3/4.2 POWER DISTRIBUTION LIMITS

NRC DOCKET 50-366
OPERATING LICENSE NPF-5
EDWIN I. HATCH NUCLEAR PLANT UNIT 2
PAGE-BY-PAGE DESCRIPTION OF CHANGES

3/4 2-1	-	Add new Figure numbers
3/4 2-2	-	No Change: Better quality graph
3/4 2-3	-	Extend MAPLHGR curve to higher exposure
3/4 2-4a	-	Change page number
3/4 2-4b	-	Extend MAPLHGR curve to higher exposure; change page number
3/4 2-4c	-	Extend MAPLHGR curve to higher exposure; change page number
3/4 2-4d	-	Add Unit 1 7x7 MAPLHGR curve
3/4 2-4e	-	Add new Unit 2 fuel MAPLHGR curve
3/4 2-4f	-	Add Unit 1 reconstituted fuel MAPLHGR curve
3/4 2-6	-	Add new figure number; reflect new K_f figure number; add reference to 7x7 fuel
3/4 2-7b	-	Add MCPR limit curve for 7x7 fuel
3/4 2-7c	-	Change figure number and page number
3/4 2-8	-	Add LHGR for 7x7 fuel
3/4 5-1	-	Change "reactor core" to "initial core"; correct "Zircaloy-4 to "Zircaloy-2"; add sentence about 7x7 fuel
B 3/4 1-2	-	Reflect new safety limit of 1.07
B 3/4 2-1	-	Condense reference to APLHGR figures
B 3/4 2-4	-	Reflect change in K_f curve figure number
B 3/4 2-5	-	Reflect change in K_f curve figure number

FIGURE 3.2.1-6

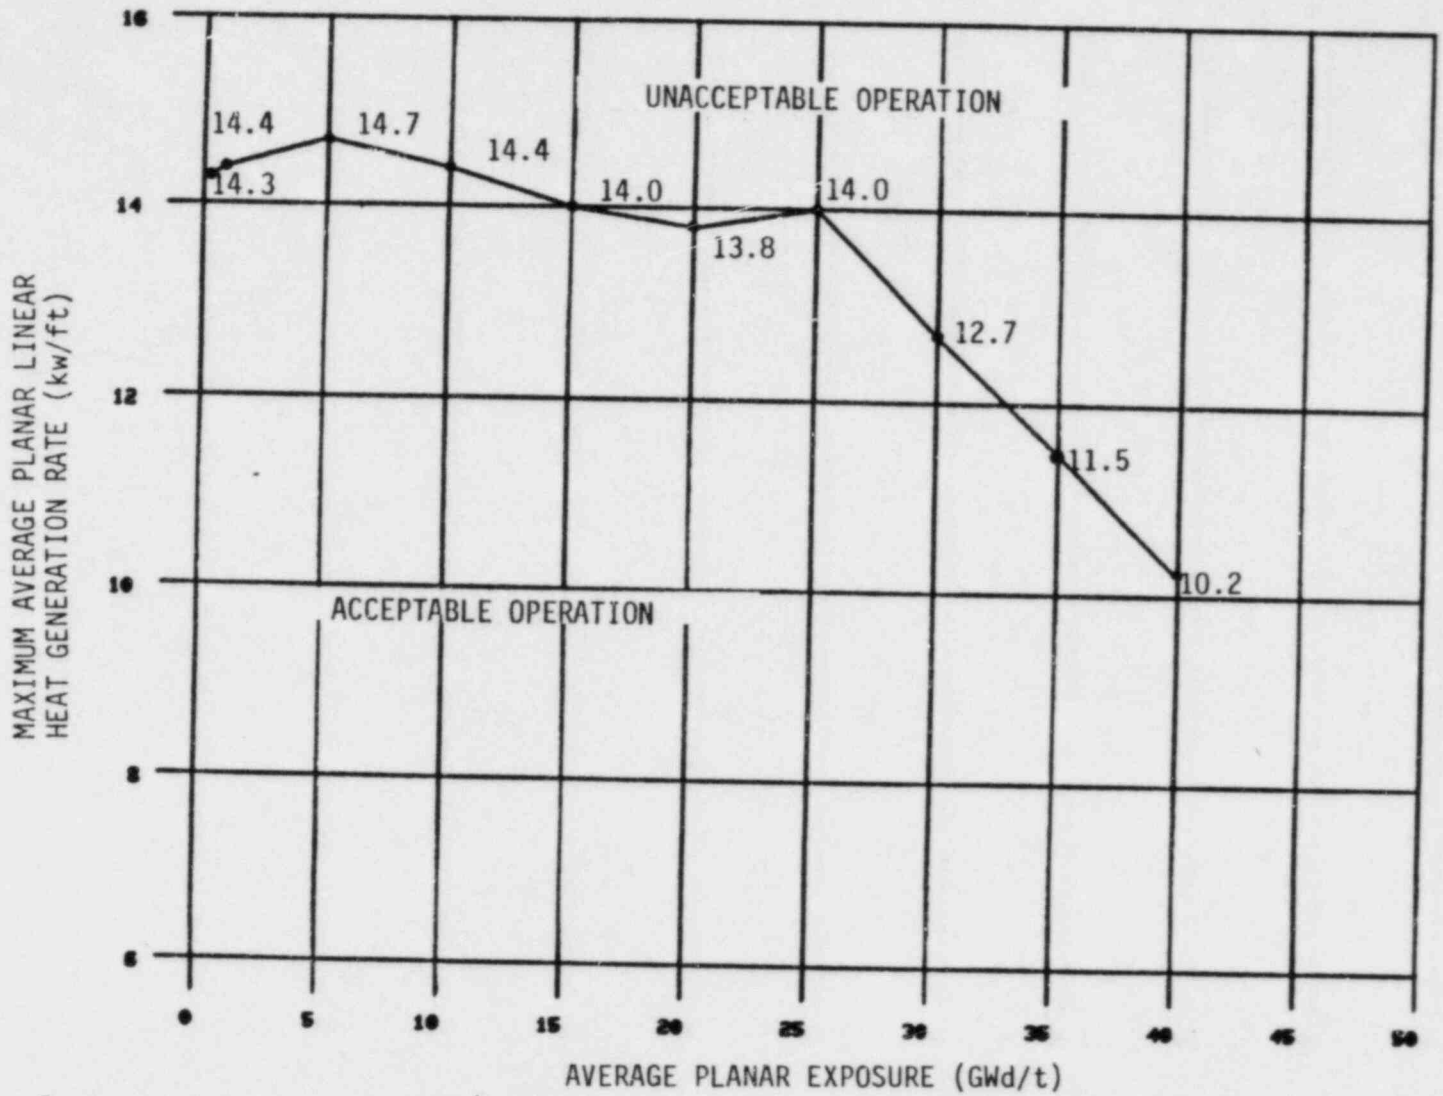
Per Mr. K. S. Folk's verbal request, General Electric Company has performed an analysis of the ECCS MAPLHGR limits for the Hatch 1 initial core and reconstituted Hatch 1 Reload 2 fuel bundles when inserted in Hatch 2. This analysis was required because, although the Hatch 1 and Hatch 2 plants are similar, the Hatch 2 plant ECCS analysis is slightly more severe due to a different limiting break size and associated core uncovery and reflood times. The results of this analysis are documented in the attached tables.

The three Hatch 1 7x7 initial core fuel types' MAPLHGR's and PCT's are represented in the tables as one fuel type since bounding calculations were made to cover all three. These calcultions were made for 80 mil channels only since local peaking data for these 7x7 lattice with 100 mil channels are not available. However, the trend observed from the 8DRB265-6G3.0 results for 80 versus 100 mil channels shows less than a 0.1 Kw/ft MAPLHGR difference between the two, with the 80 mil channel results being slightly worse. It is concluded that the MAPLHGR limits for the 7x7 bundles based on 80 mil channels are applicable to 100 mil channels as well, should the thicker channels be required.

EXPOSURE (GWD/ST)	(GWD/MT)	MAPLHGR (KW/FT)	PCT (DEG-F)	LOCAL OXIDATION (FRACTION)
.20	.22	14.30	2198.	0.036
1.0	1.1	14.40	2198.	0.035
5.0	5.5	14.70	2197.	0.032
10.	11.	14.40	2199.	0.031
15.	17.	14.00	2198.	0.057
20.	22.	13.80	2199.	0.057
25.	28.	14.00	2198.	0.052
30.	33.	12.70	2013.	0.017
35.	39.	11.50	1886.	0.010
40.	44.	10.20	1729.	0.006

FIGURE 3.2.1-8

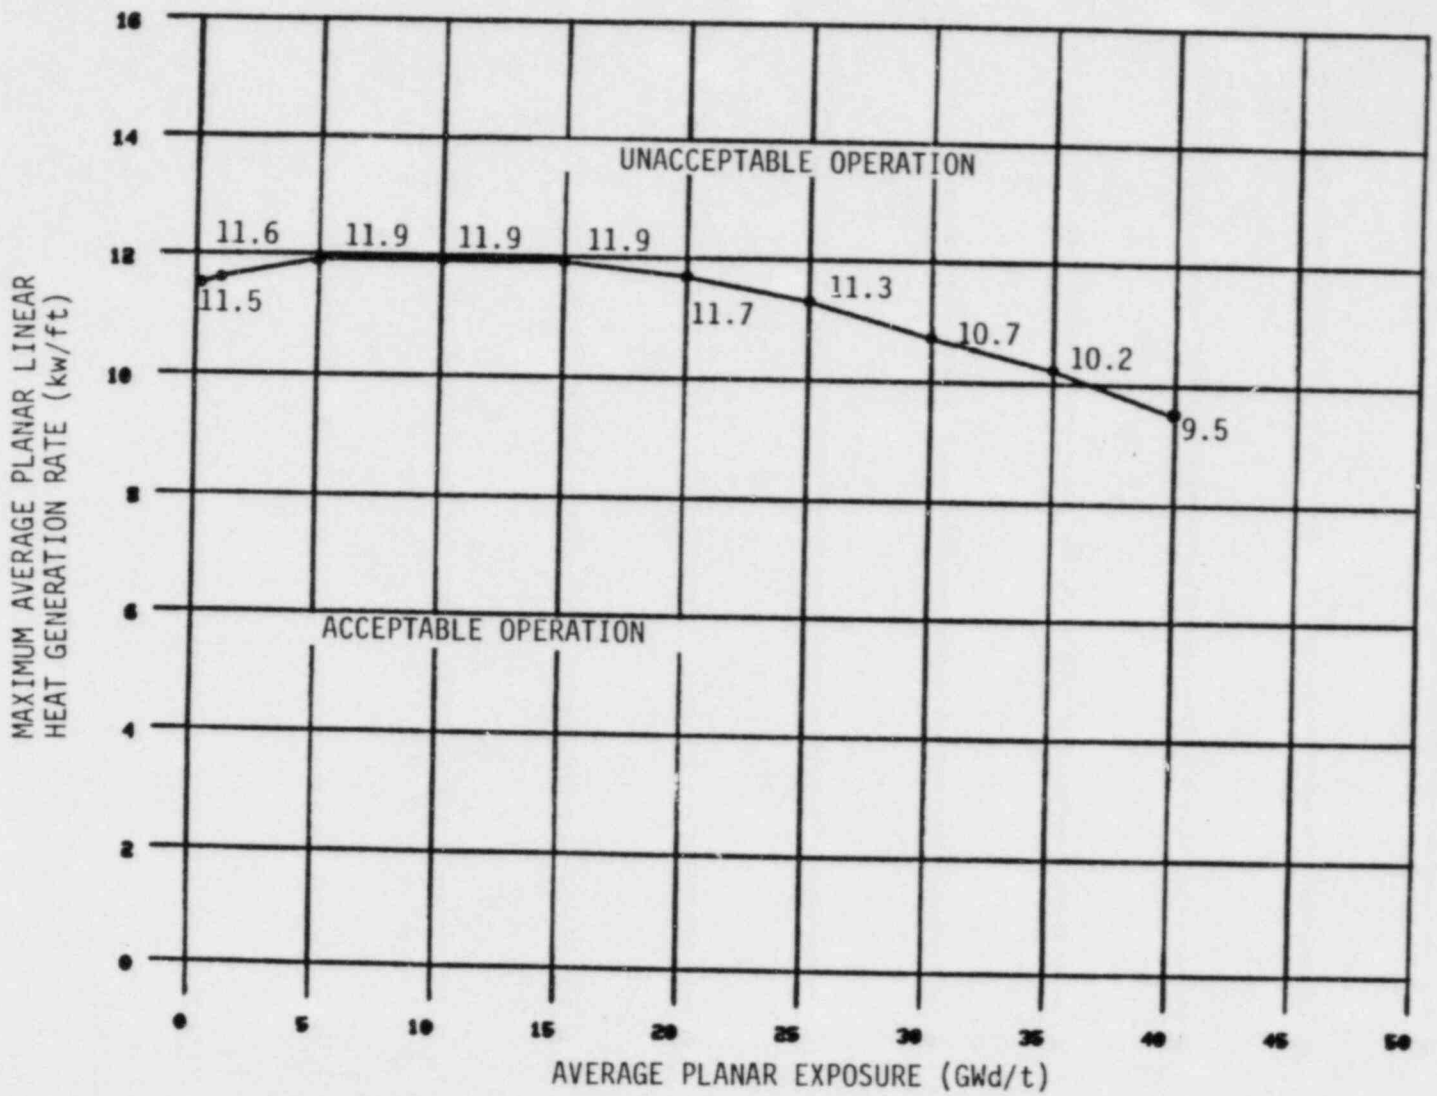
The un-reconstituted local peaking factors for the 8DRB265-6G3.0 bundle were used for this analysis since the reconstituted bundle has slightly better ECCS performance. (The reconstituted bundle has better thermal conductivity and local peaking characteristics than the original bundle.) Although the results are not very sensitive to 80 or 100 mil channels, the reported 8DRB265-6G3.0 MAPLHGR results bound the use of either channel.

EXPOSURE (GWD/ST)	(GWD/MT)	MAPLHGR (KW/FT)	PCT (DEG-F)	LOCAL OXIDATION (FRACTION)
.20	.22	11.50	2164.	0.031
1.0	1.1	11.60	2167.	0.031
5.0	5.5	11.90	2199.	0.034
10.	11.	11.90	2200.	0.033
15.	17.	11.90	2200.	0.034
20.	22.	11.70	2198.	0.034
25.	28.	11.30	2147.	0.029
30.	33.	10.70	2067.	0.022
35.	39.	10.20	1994.	0.017
40.	44.	9.50	1904.	0.012
